Top View

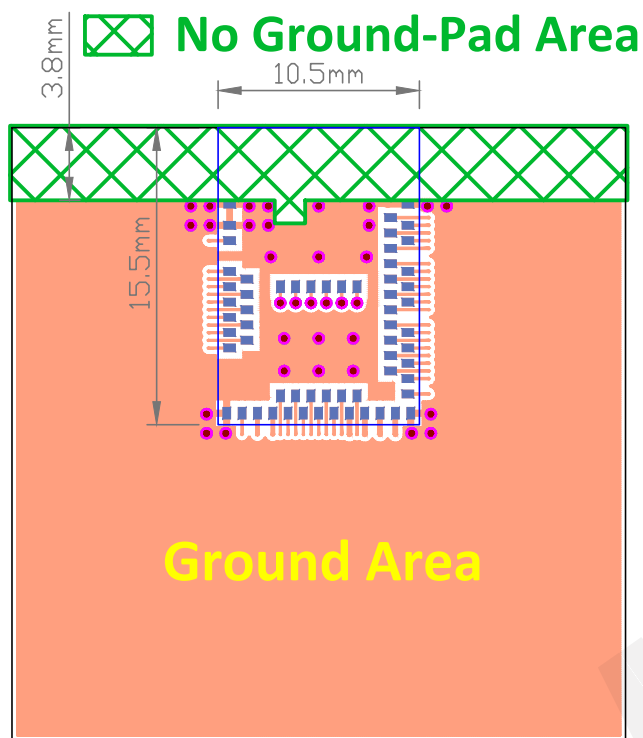
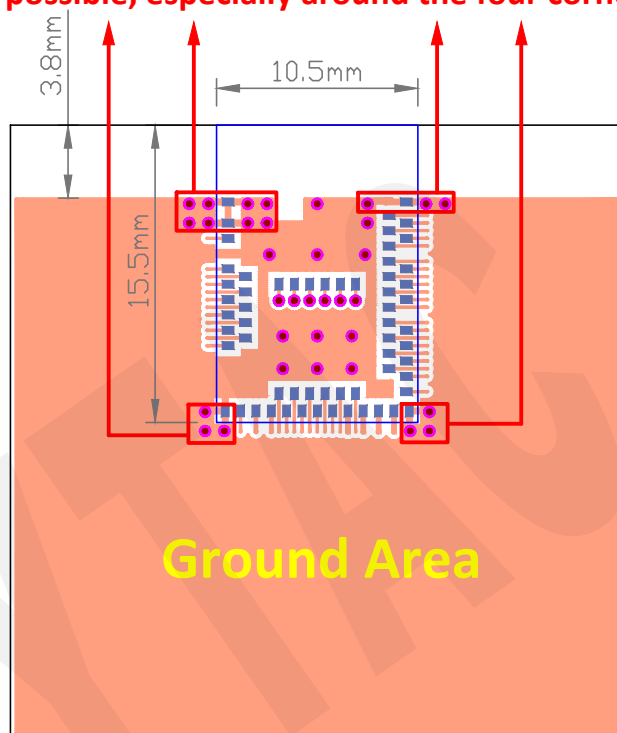
Please add via holes in GROUND area as many as possible, especially around the four corners.

Perspective View

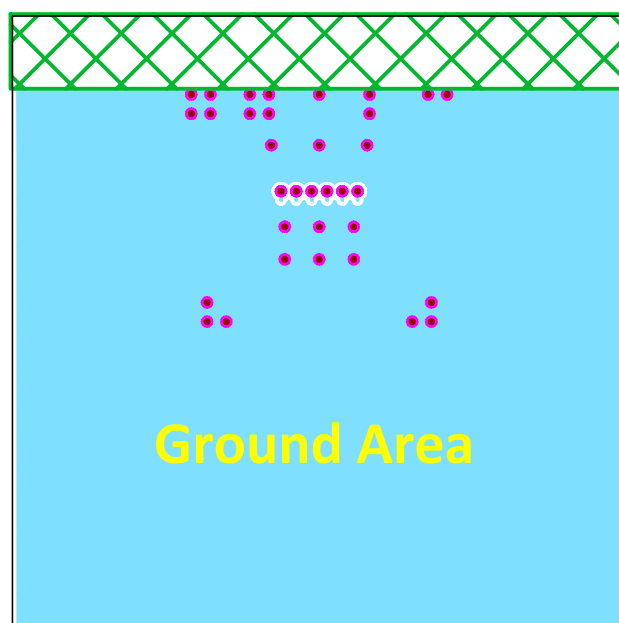
No Ground-Pad Area
